Road Safety Audit

Stage 1/2

MONEYDUFF HOUSING DEVELOPMENT

ORANMORE, Co GALWAY

Figure 3: Collision Plot for Surrounding Road Network

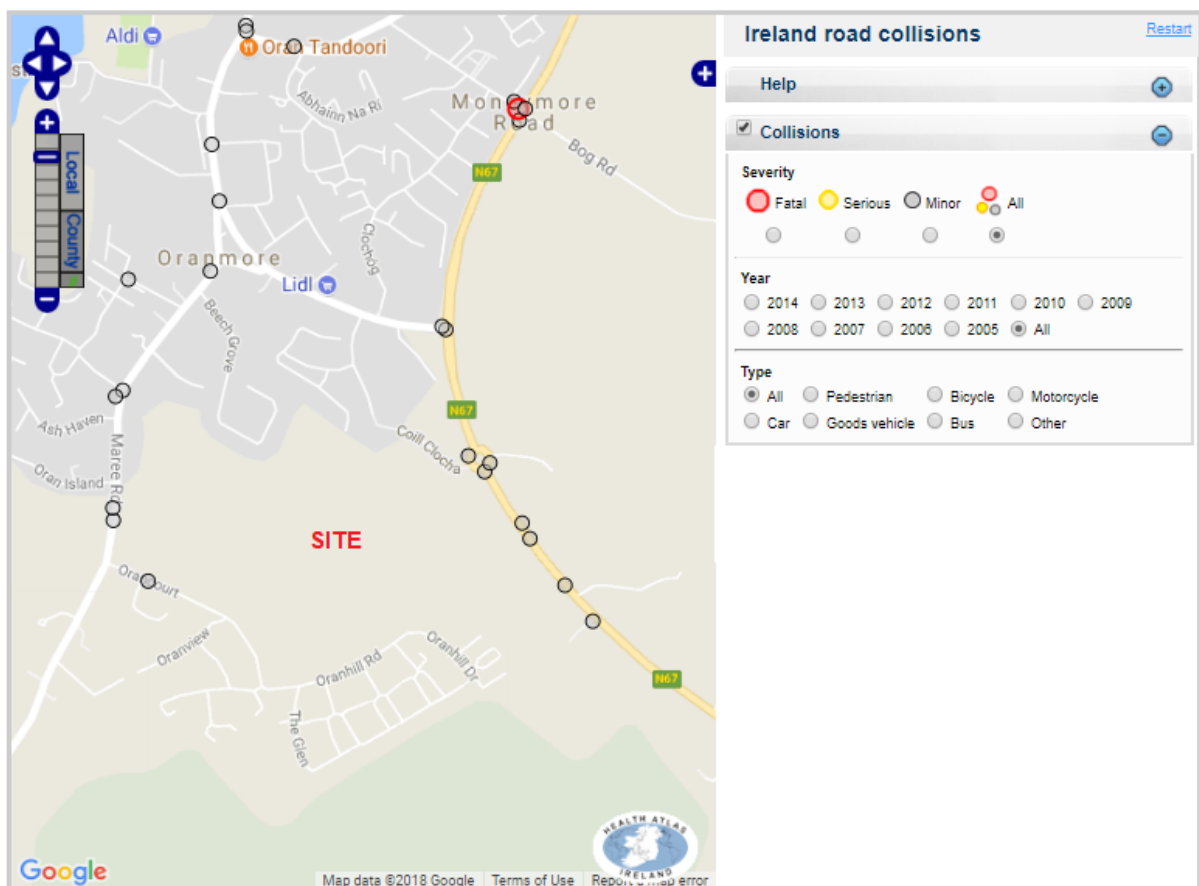
2.1.3 A review of the Road Safety Authority (RSA) online collision database indicates that there were a number of collisions recorded on the N67 to the west of the site between 2005 and 2014 inclusive, as shown in Figure 3, all resulting in minor casualties. The cluster of 3 collisions recorded at the roundabout were single vehicle collisions. It should be noted that the RSA database is not a comprehensive record of collisions, and should be reviewed in conjunction with the Local Authority / Gardaí records for the site.
